SUBJECT: Forwards addl info re continued use of Boraflex at facility,  
 per 870609 request. Boraflex is neutron absorbing poison used  
 in spent fuel racks, assuring shutdown margin of 5% w/no  
 boron in spent fuel pool water.

JULY 10 1987  
L-87-279

Re: Turkey Point Units 3 and 4  
Docket No. 50-250 and 50-251  
Request for Additional Information  
Boraflex Usage at Turkey Point

FIGURE 1

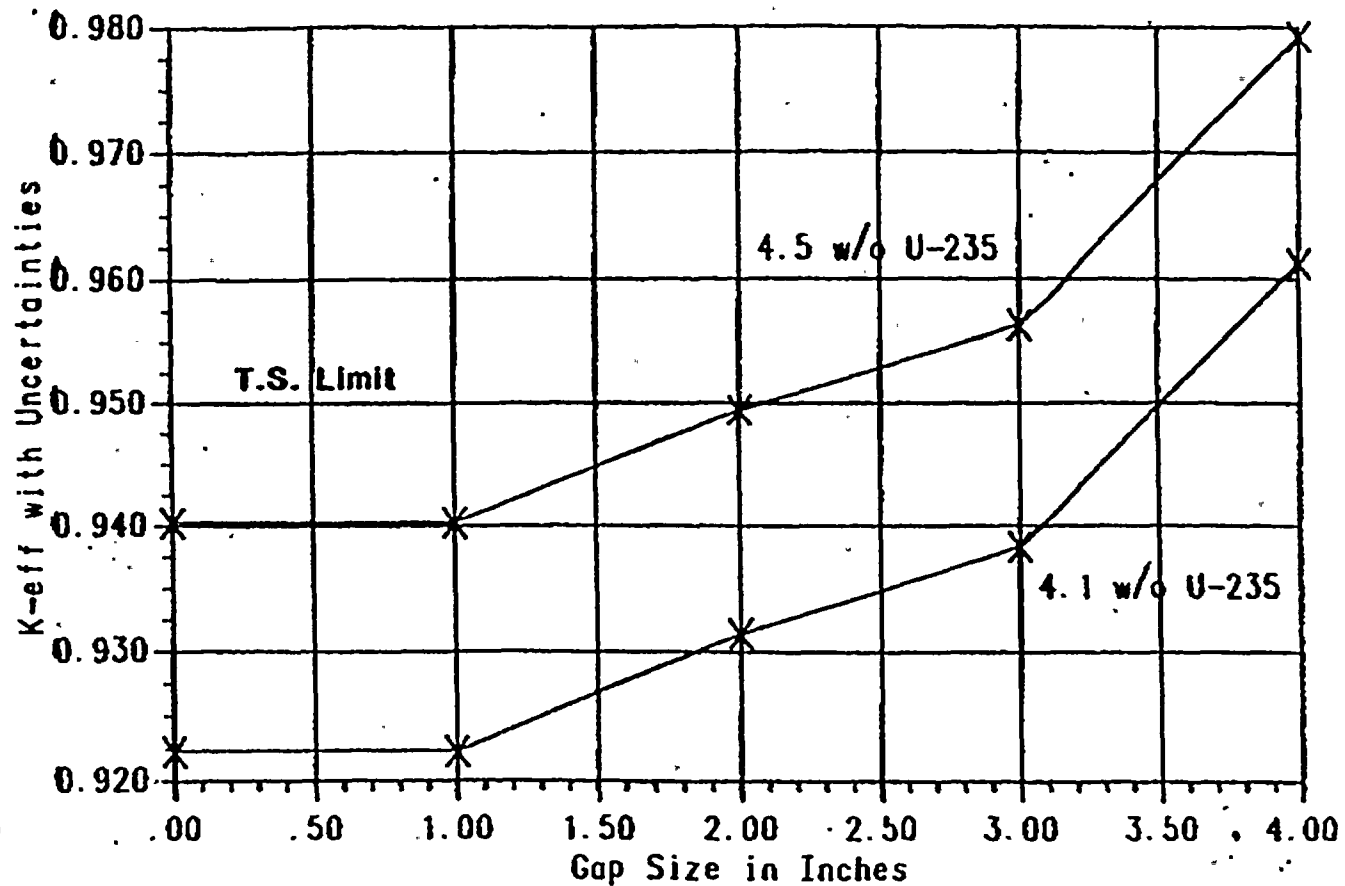
Axial gaps in the BOROFLEX ranging from 0 to 10" were modeled explicitly using KENO. These gaps were modeled in one half of and in all of the poison plates in the rack.

The KENO calculations and the original criticality analysis assume a maximum U-235 enrichment of 4.5 w/o. The results are presented in Figures 1 and 2.

It was also requested that the same type of data be provided with a maximum U-235 enrichment of 4.1 w/o assumed. The original criticality analysis included a study which showed the sensitivity of rack  $K_{eff}$  to fuel enrichment for the Region 1 spent fuel racks. This study was used to determine that the decrease in U-235 enrichment from 4.5 w/o to 4.1 w/o results in a 0.018  $\Delta K$  decrease in rack  $K_{eff}$ . This small change in fuel enrichment does not significantly effect the reactivity worth of the gaps in the poison plates. The data for the study using the 4.1 w/o fuel was produced by subtracting the 0.018  $\Delta K$  from the results of the 4.5 w/o fuel study. The results of this second study are presented in Figures 1 and 3.
